**ACT**  
Government

Environment, Planning and  
Sustainable Development

**Further information request – DA-202442901 – Block 76 Section 10 Garran & Block 1 Section 56 Red Hill**

**FIGURE 4.1**  
**Actual Impacts**

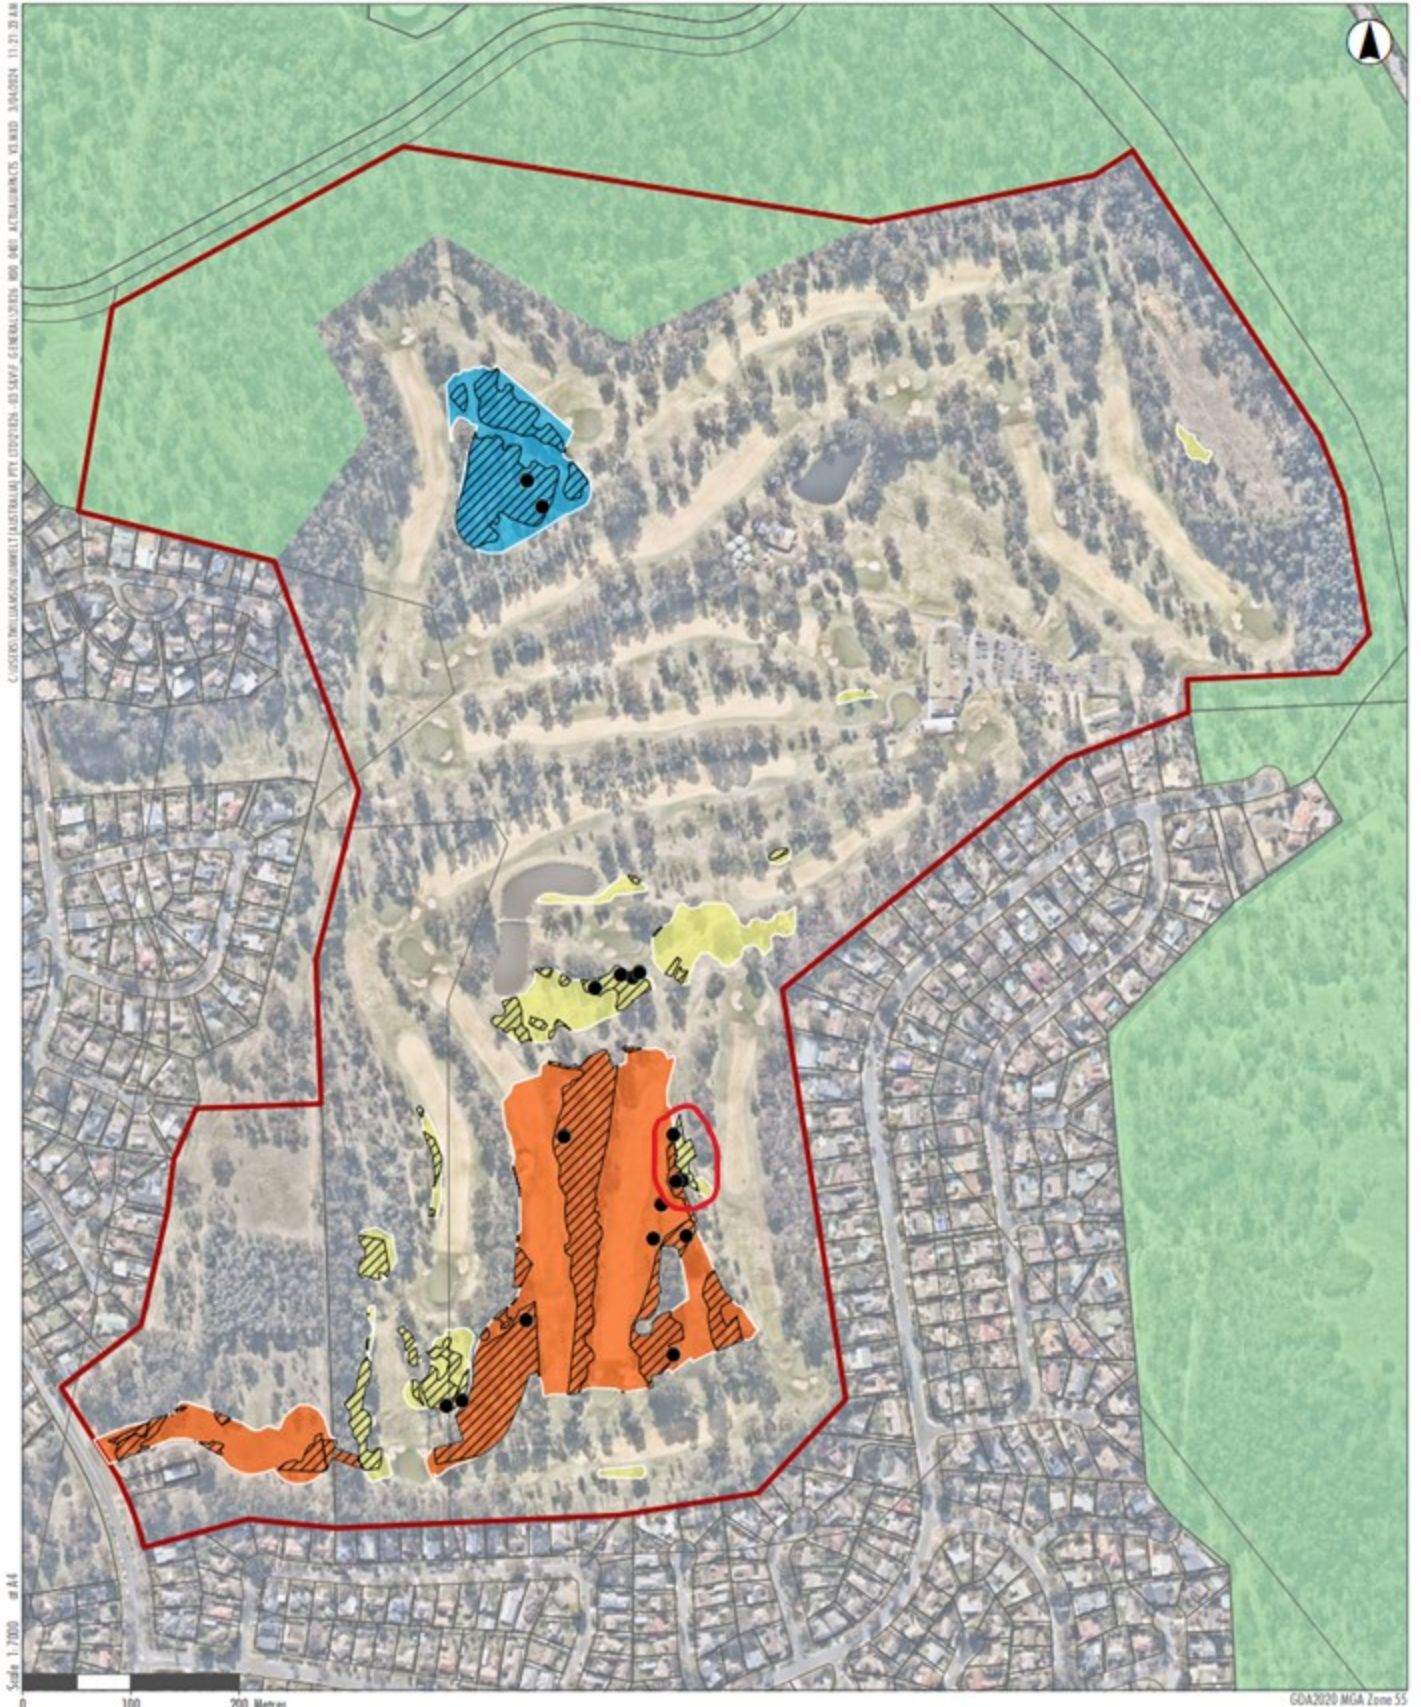
3. The proponent is requested to provide raw tree data or tree summary report allowing quantitative before-and-after assessment, particularly mature natives and hollow bearing trees.
4. The proponent is requested to confirm whether the Gang-gang nest tree known as “Clares” (located within the red circle in **Attachment 1**) will be retained.
